Addendum 12: Regulation No. 13

Revision 6 - Amendment 4

Supplement 2 to the 11 series of amendments: Date of entry into force: 24 October 2009

UNIFORM PROVISIONS CONCERNING THE APPROVAL OF VEHICLES OF CATEGORIES M, N AND O WITH REGARD TO BRAKING

FIGURE 1A

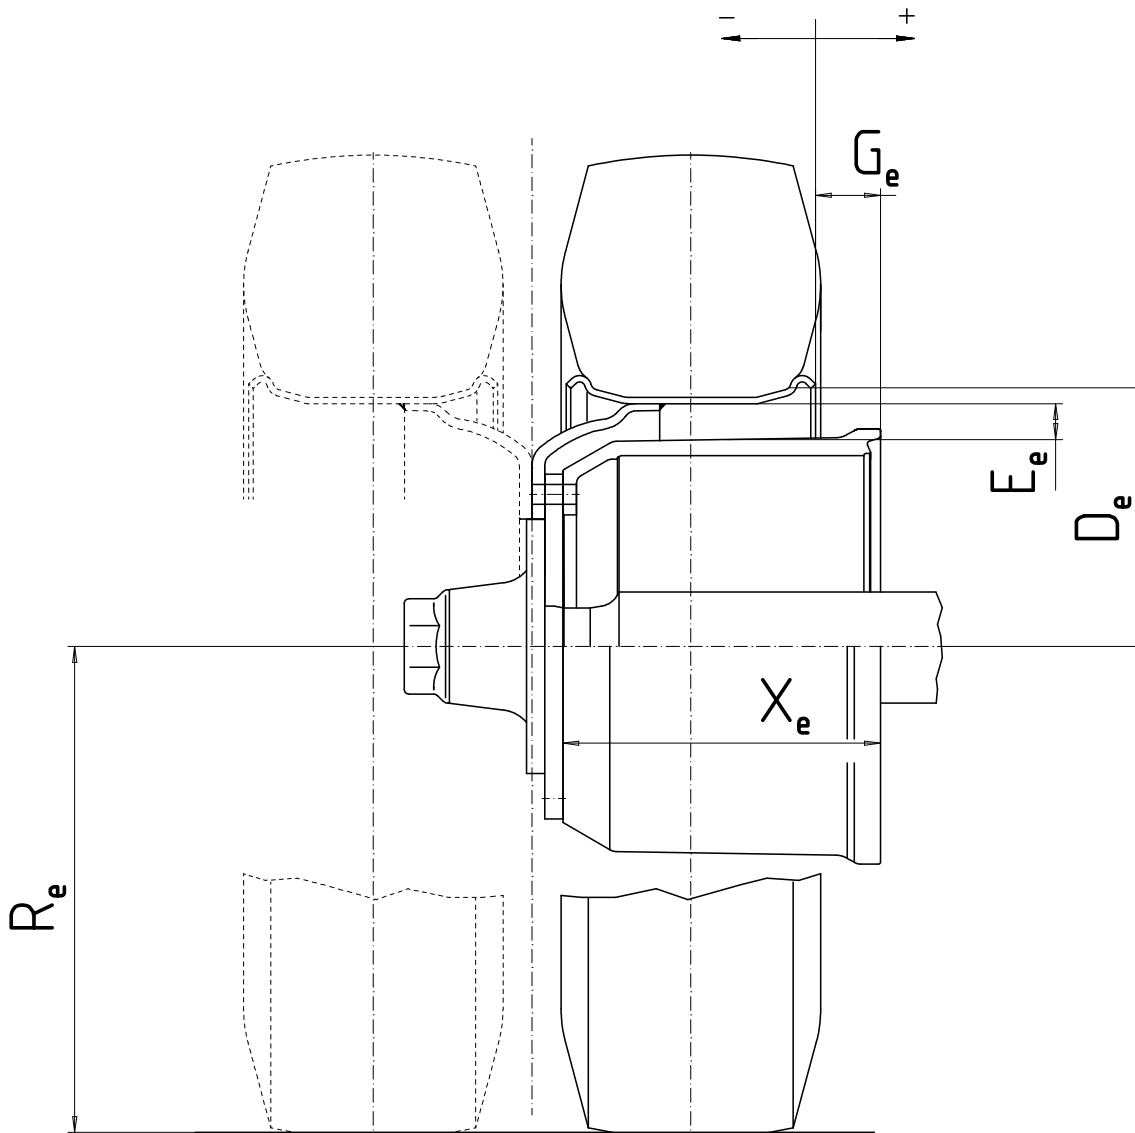
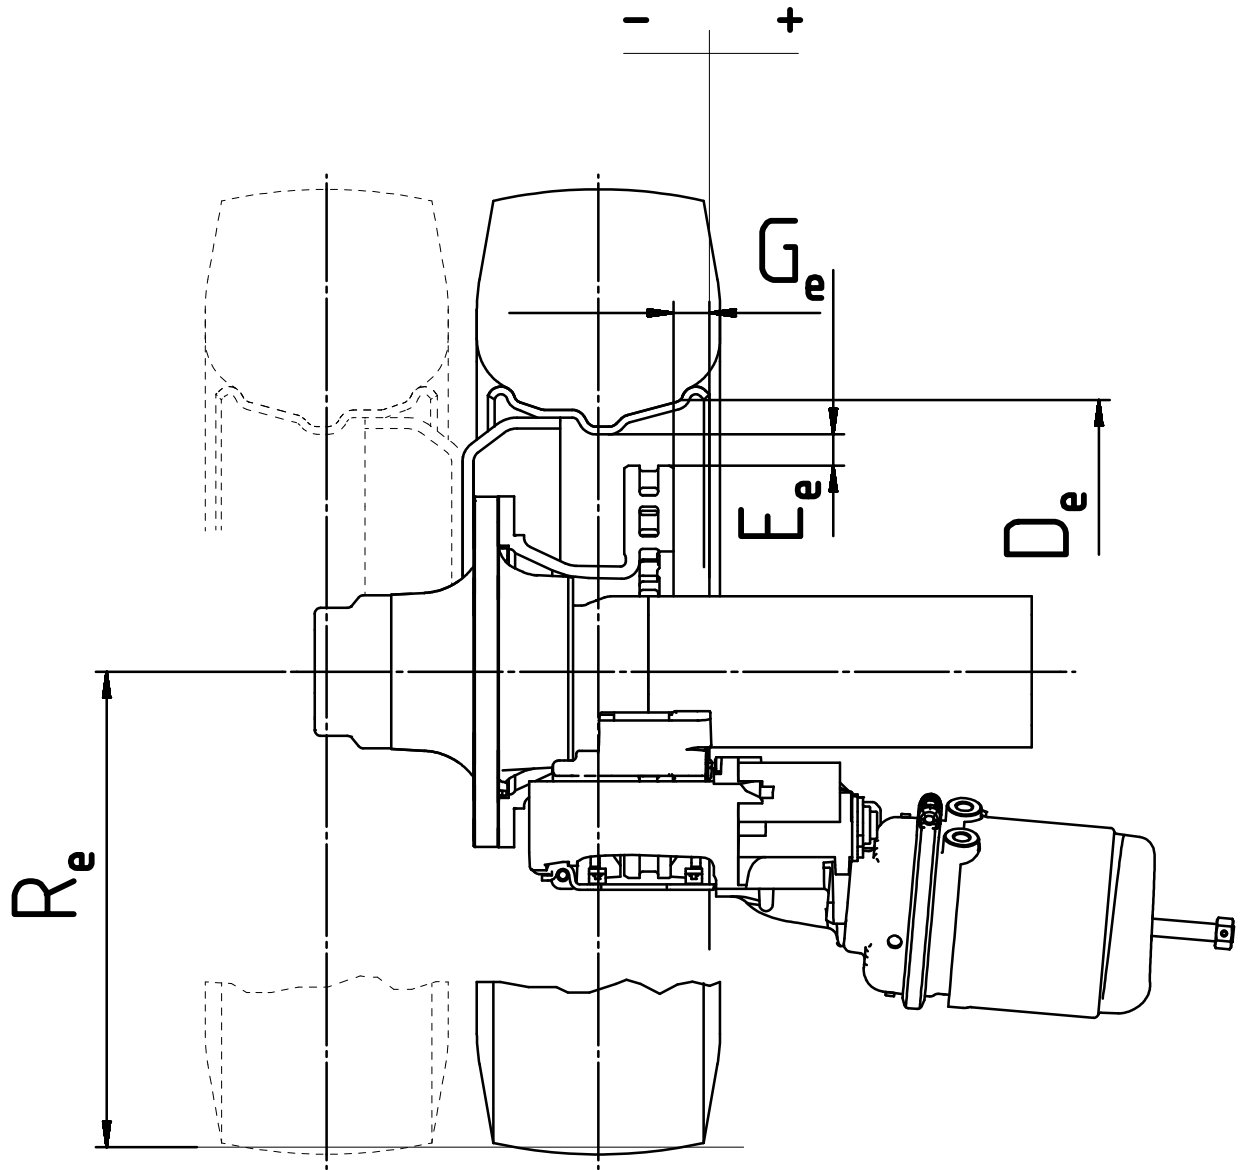
Add a new Appendix 5 to Annex 11, to read:

1. GENERAL
 - 1.1. Name and address of axle or vehicle manufacturer:
2. AXLE DATA
 - 2.1. Manufacturer (name and address):
 - 2.2. Type/variant:
 - 2.3. Axle identifier: ID1-
 - 2.4. Test axle load (F_e): daN
 - 2.5. Wheel and brake data according to the following figures 1A and 1B

FIGURE 2A

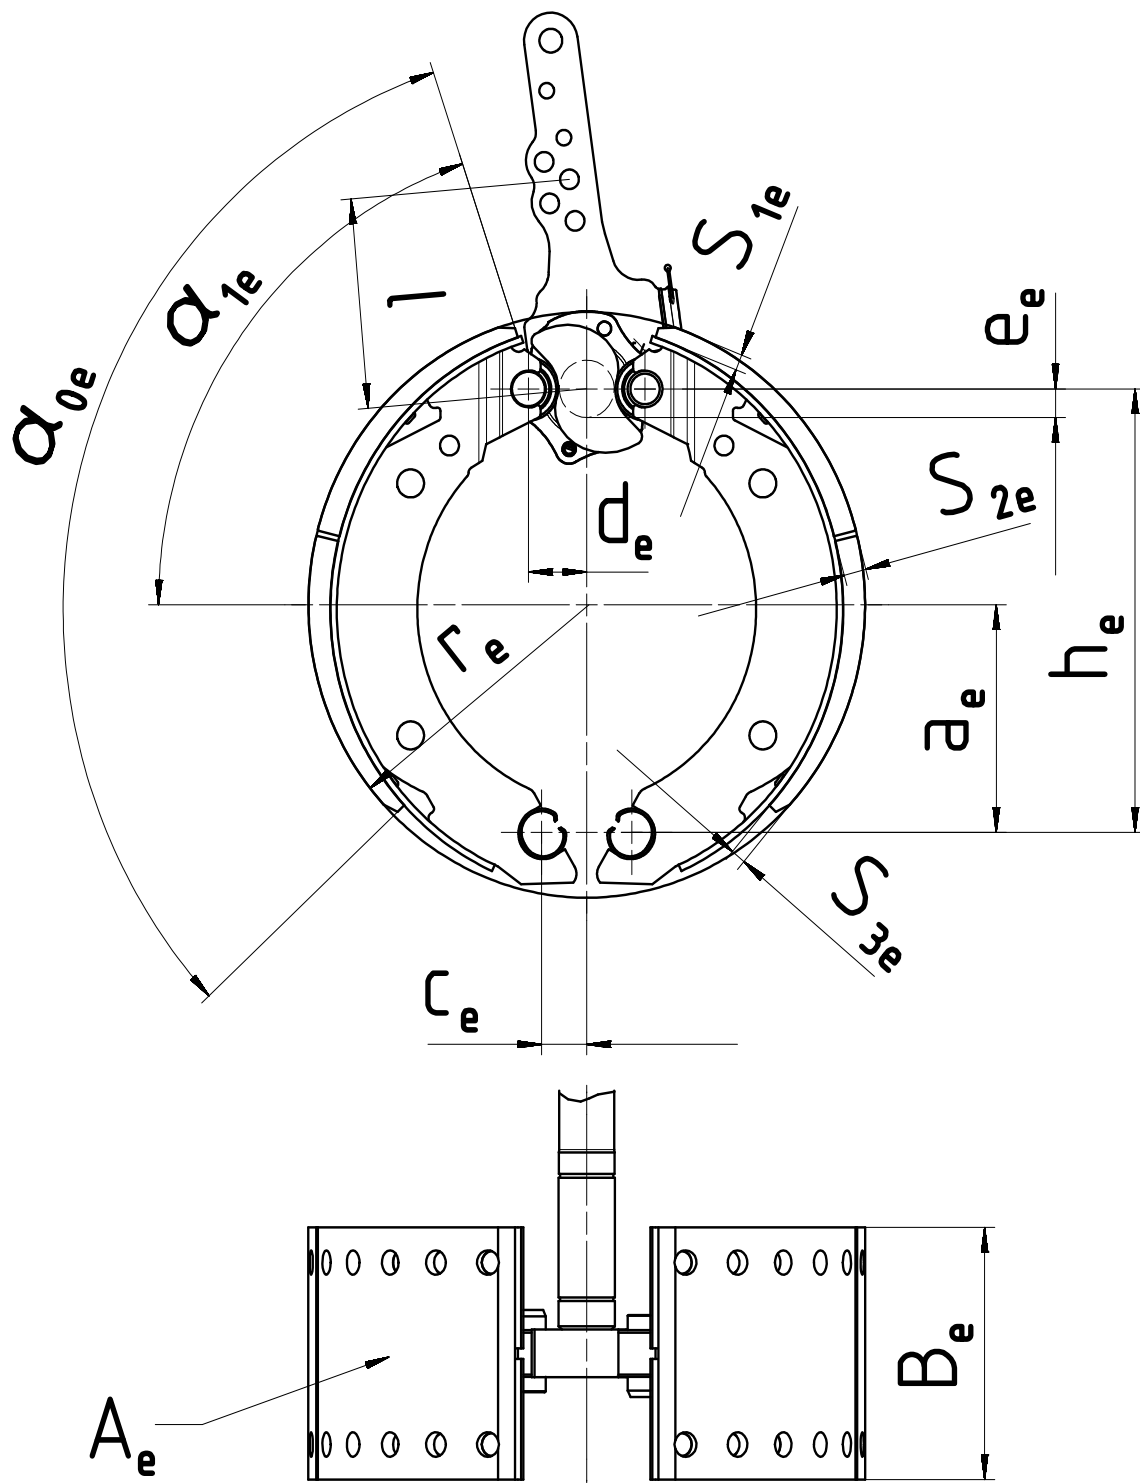
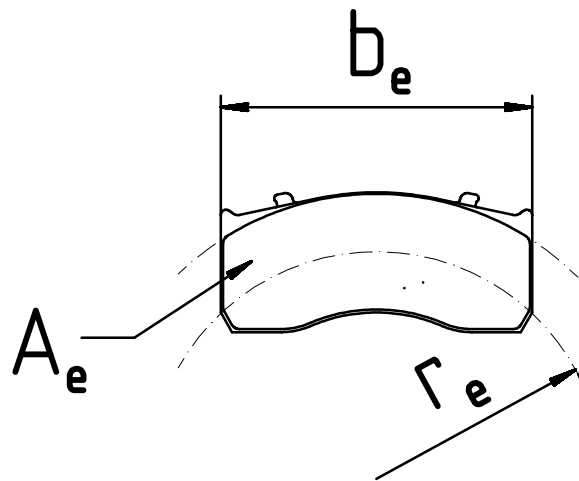
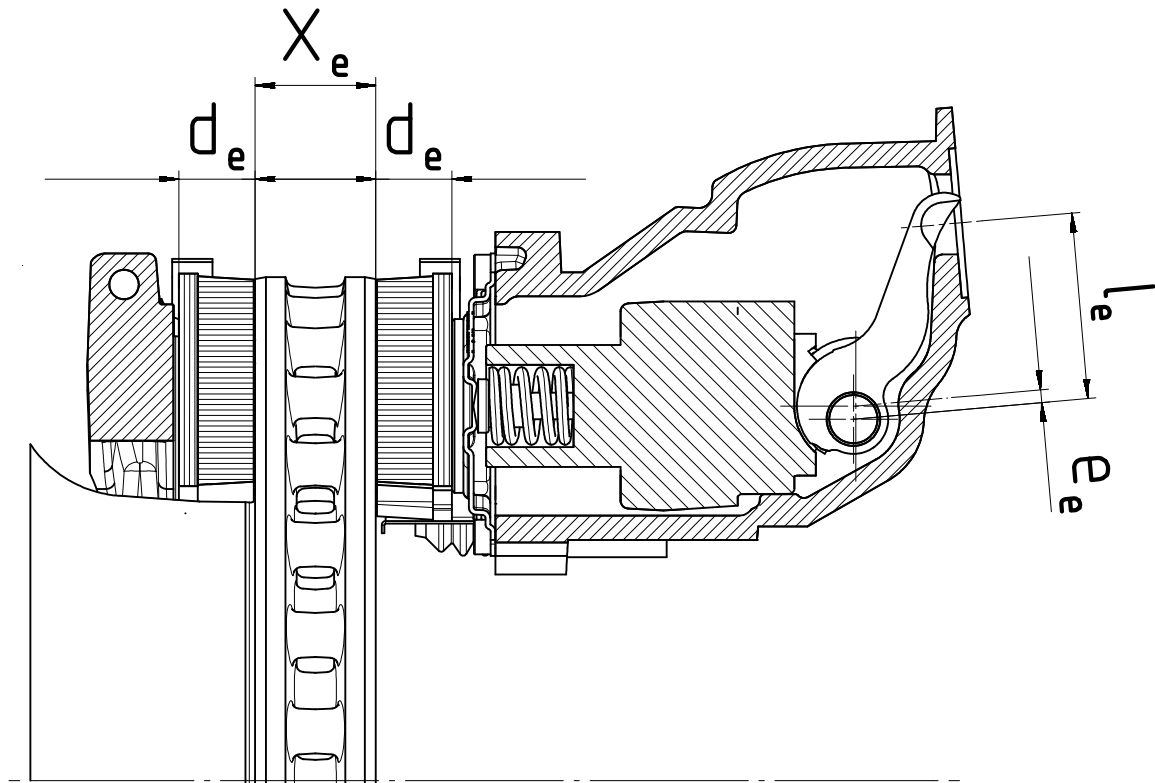
- 3. BRAKE
- 3.1. General information
- 3.1.1. Make:
- 3.1.2. Manufacturer (name and address):
- 3.1.3. Type of brake (e.g. drum / disc):
- 3.1.3.1. Variant (e.g. S-cam, single wedge etc.):
- 3.1.4. Brake identifier: ID2-
- 3.1.5. Brake data according to the following figures 2A and 2B:
